Discretionary Review Full Analysis

Date: January 29, 2015
Case No.: 2014.1583D
Project Address: 1762 12th AVENUE
Permit Application: 2013.07.15.1824
Zoning: RH-1 (Residential House, One-Family)
40-X Height and Bulk District
Block/Lot: 2038A/018
Project Sponsor: Troy Kashinapour
Troy Kashanipour Architecture
2325 Third Street Suite 401
San Francisco CA, 94107
Staff Contact: Marcelle Boudreaux – (415) 575-9140
Marcelle.Boudreaux@sfgov.org
Recommendation: **Do not take DR and approve the project as proposed.**

Full Discretionary Review
 Case Number 2014.1583D
 1762 12th Avenue – New Construction

FRONT ELEVATION - PROPOSED MAX BUILD HEIGHTS

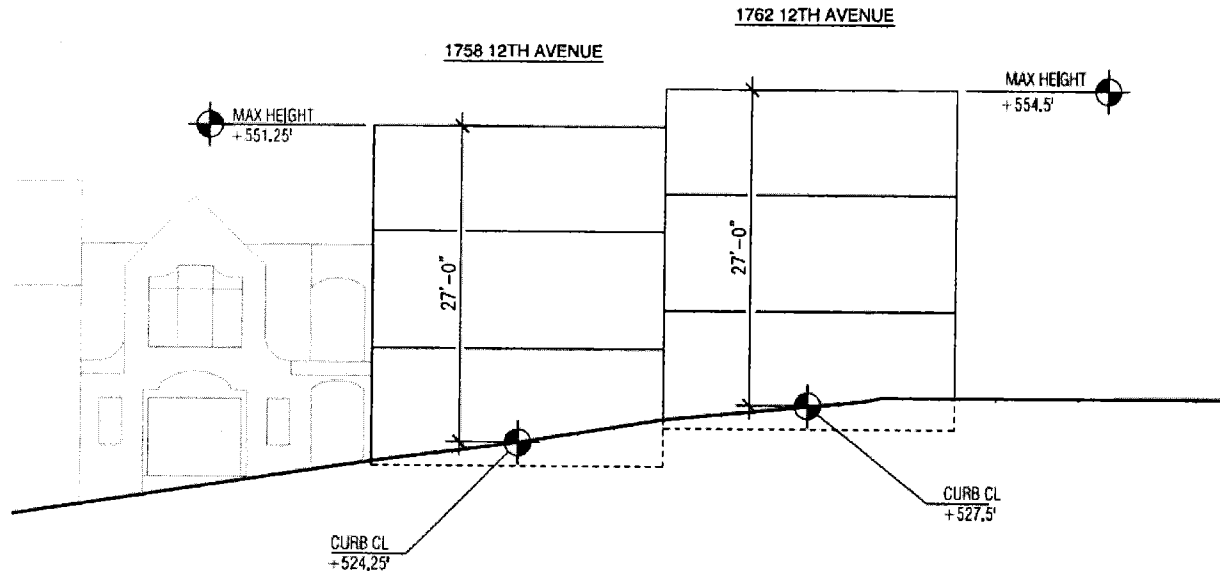
I am a neighbor writing in regards to the proposed new single family residence at 1762 12th Avenue that is currently under planning review. The Applicant, Owner and I have reached an informal agreement (see red text below) on the overall height of the house at 27' above the top of curb centerline. This criteria is documented by the attached diagram.

Thanks for the advance notice. When the sponsor has re-submitted revised plans I'll incorporate this into my review.
